The Town of Hilton Head Island
Design Review Board Regular Meeting
Tuesday, November 12, 2019 – 1:15 p.m.
Benjamin M. Racusin Council Chambers
AGENDA

Town of Hilton Head Island
Design Review Board
Tuesday, October 8, 2019 at 1:15 p.m.
Benjamin M. Racusin Council Chambers

MEETING MINUTES

SHEET CONTENTS:
 Overall Planting Plan
 SHEET NO.

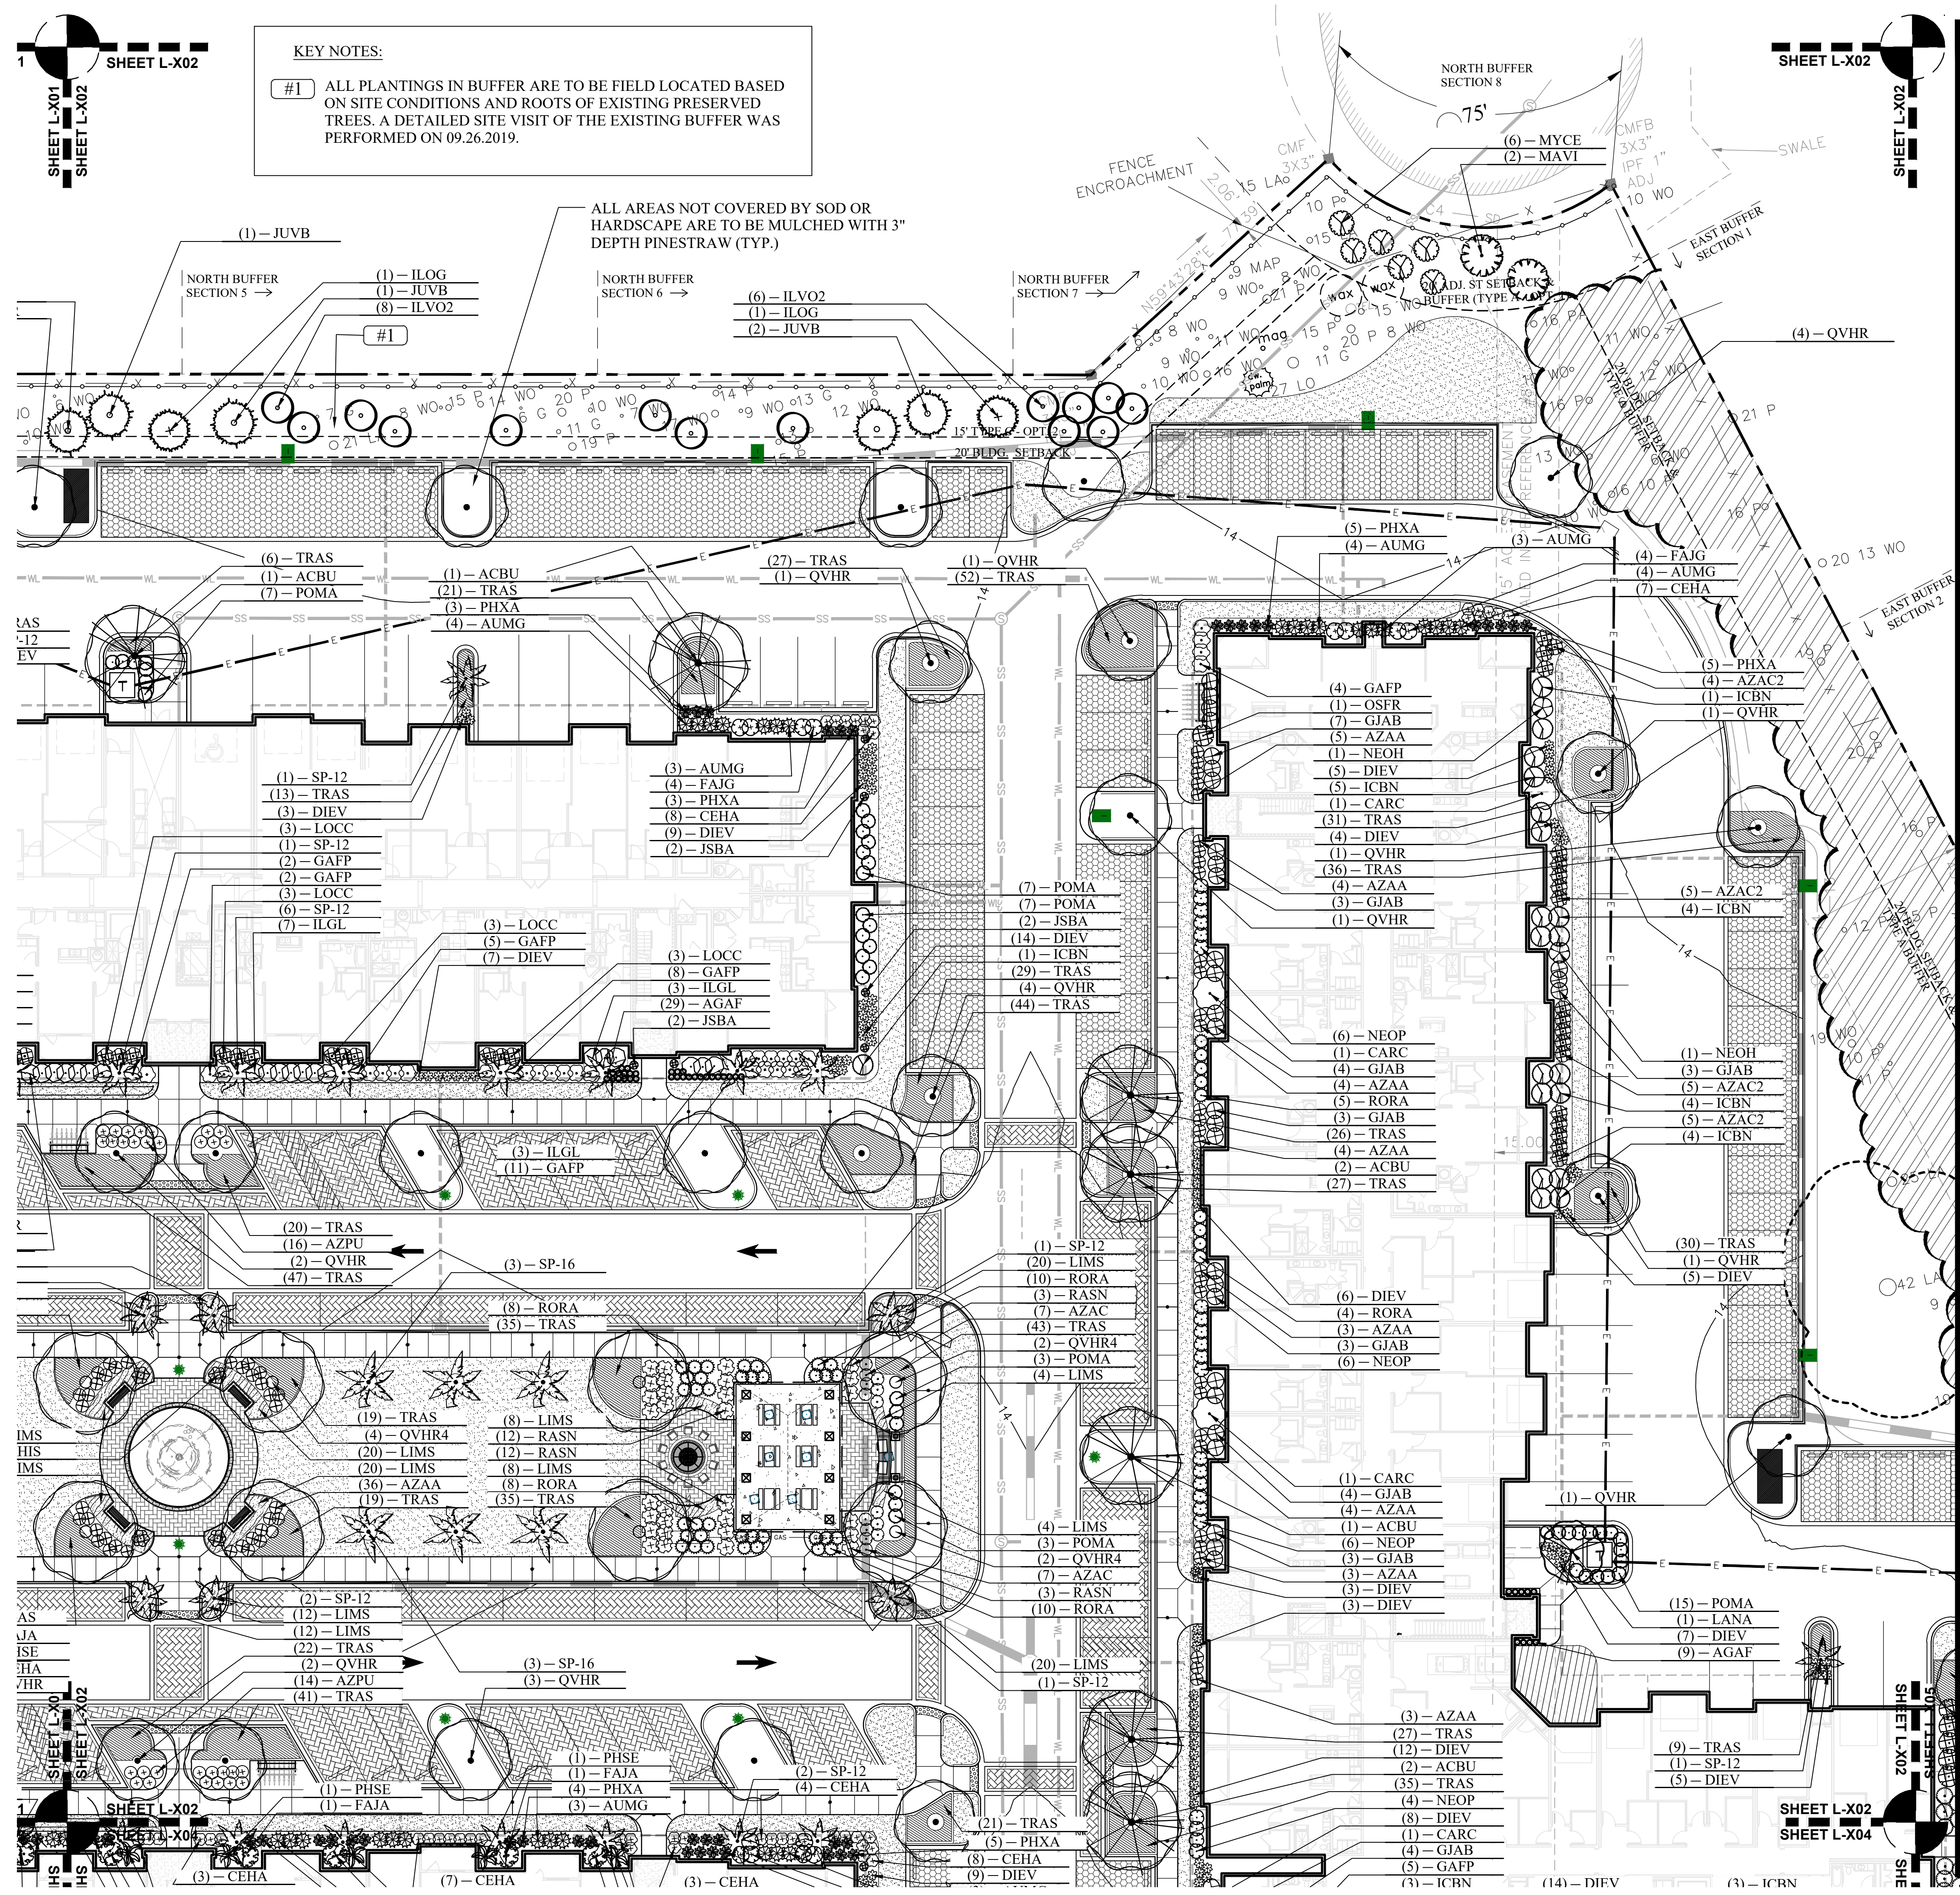
- 3) *Provide larger caliper trees than required due to the height of the buildings and specify in planting plan.*
- a. We have revised (36) proposed Live Oak trees to be 4" caliper trees from the Town's minimum requirement of 2" caliper trees. These trees are located as follows:

- i. Sheet L-401, both in the buffer and parking lot islands between Gardner Drive and Building 1; and within the Central Green;
 - ii. Sheet L-402, within the Central Green space;

- iii. Sheet L-403, between the main entrance drive and building; and within the proposed buffer plantings along the southern property line adjacent to the single family residential development;

- iv. Sheet L-404, within the proposed buffer plantings along the southern property line adjacent to the single family residential development.
- 4) *Provide planted islands between garage doors, but not necessarily every garage door, to help soften the building side.*
